Sketch NDE-Partial-2-1
North Anna Unit 1
1-SI-TK-2
Weld 1

SUBJECT: NORTH ANNA POWER STATION, UNIT 1 - ASME SECTION XI INSERVICE
INSPECTION (ISI) PROGRAM RELIEF REQUEST NDE-PARTIAL-2 (TAC NO.
MB1129)

The purpose of this letter is to grant you the relief you requested by NDE-Partial-2 for North Anna Power Station, Unit 1.

Sketch NDE-Partial-2-2
North Anna Unit 1
14"-RH-2-602-Q2
Weld 72H

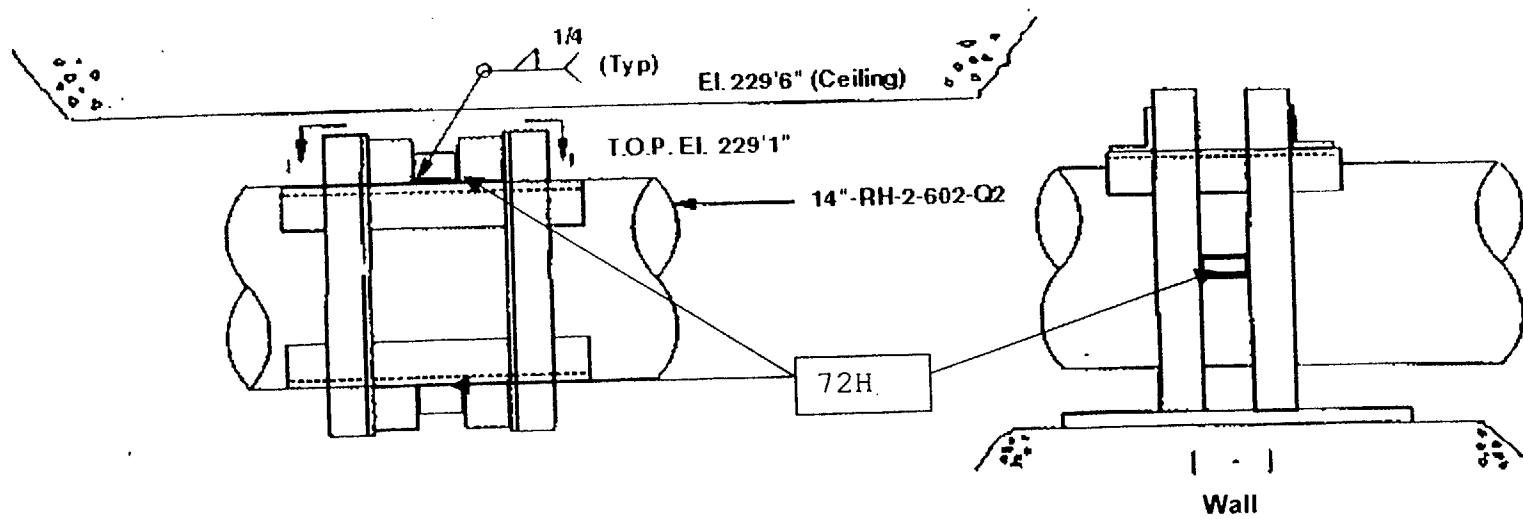
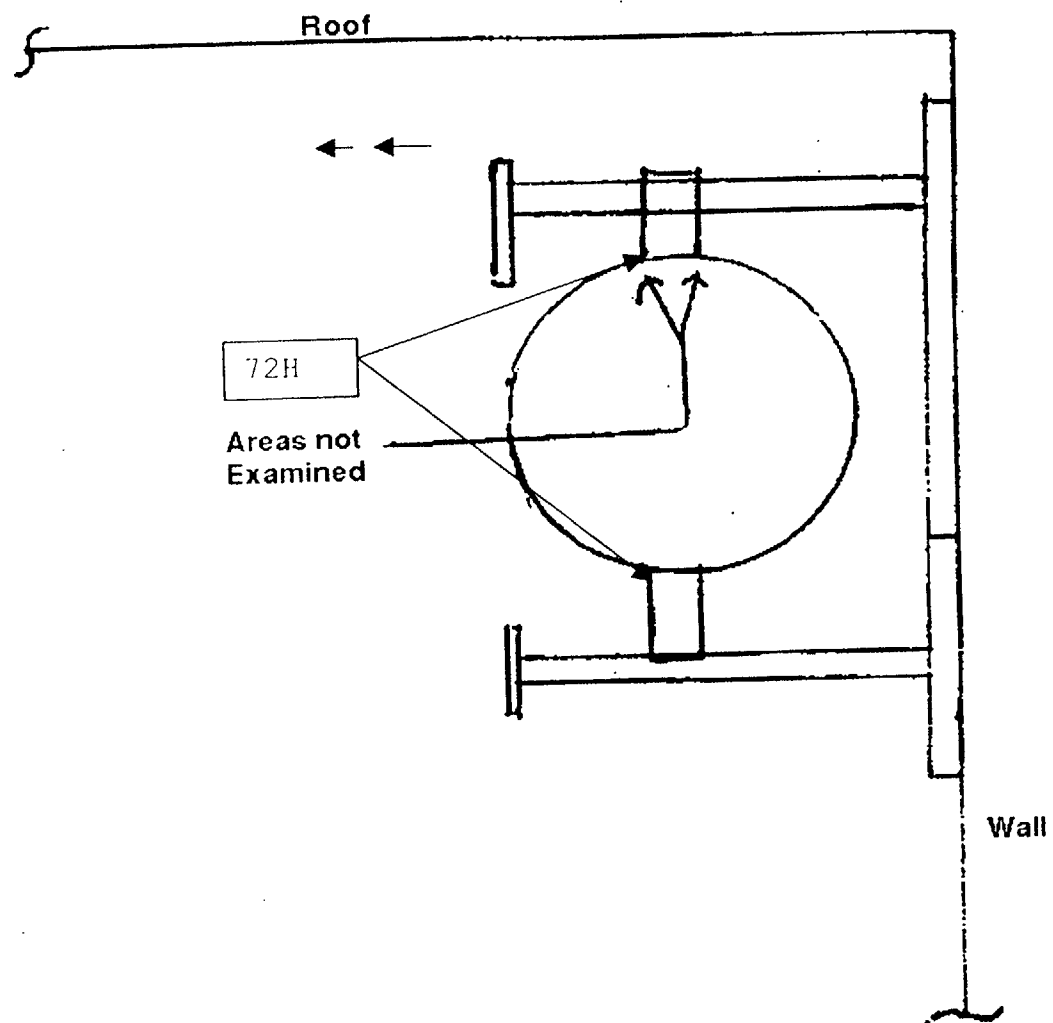
Top Lug of Integral Attachment is
Inaccessible for PT Examination

Sketch NDE-Partial-2-4
North Anna Unit 1
1-CH-P-1A
WS-03 and WS-04

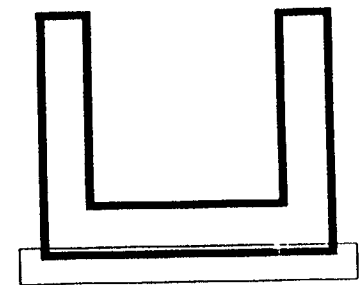
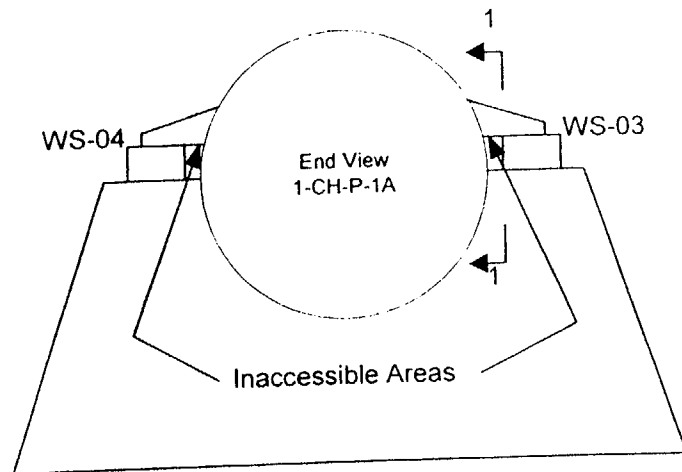
Inaccessible Area is the area
inside the box

Sketch NDE-Partial-2-6
North Anna Unit 1
14-RH-3-602-Q2
Weld 64

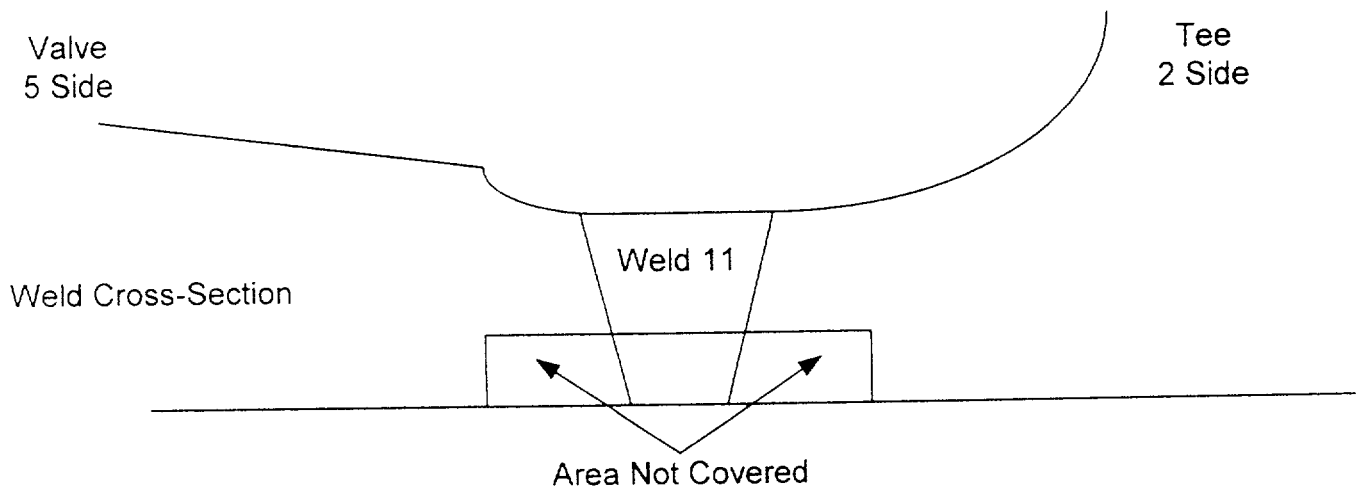
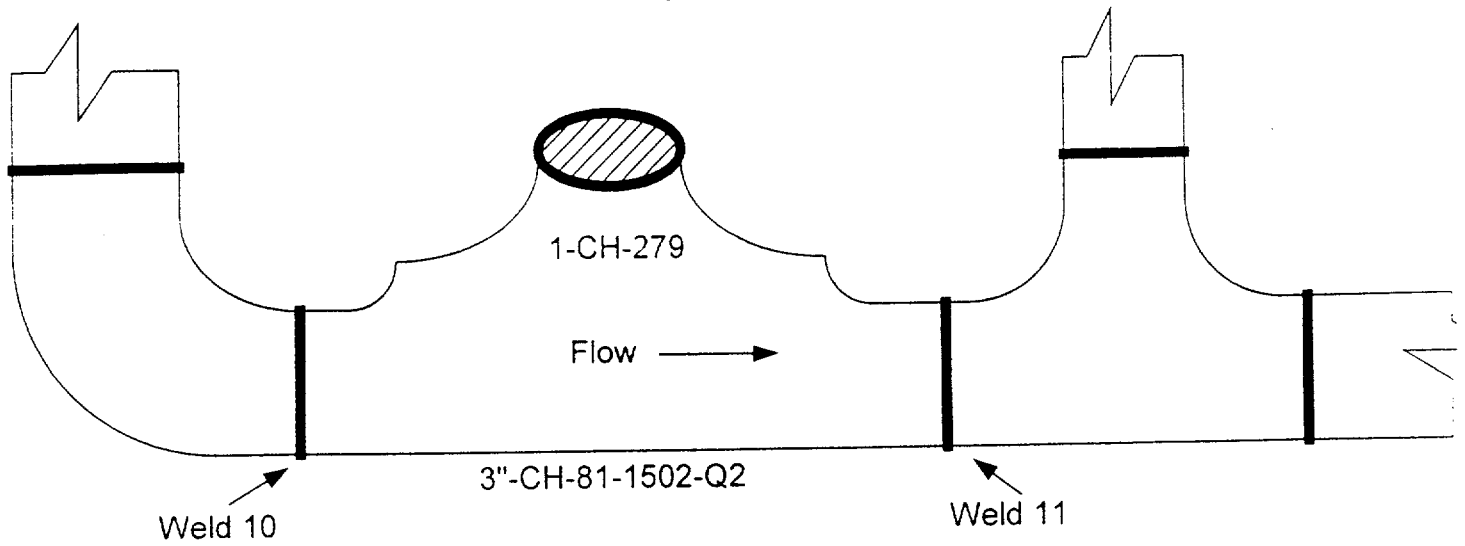
Typical configuration
225° to 315° (Intradose)
Scan 2 - 14%
Scan 5 - 12%

Typical configuration
315° to 0° to 45°
135° to 225°
Scan 2 - 68%
Scan 5 - 50%

Areas not examined (not to scale)
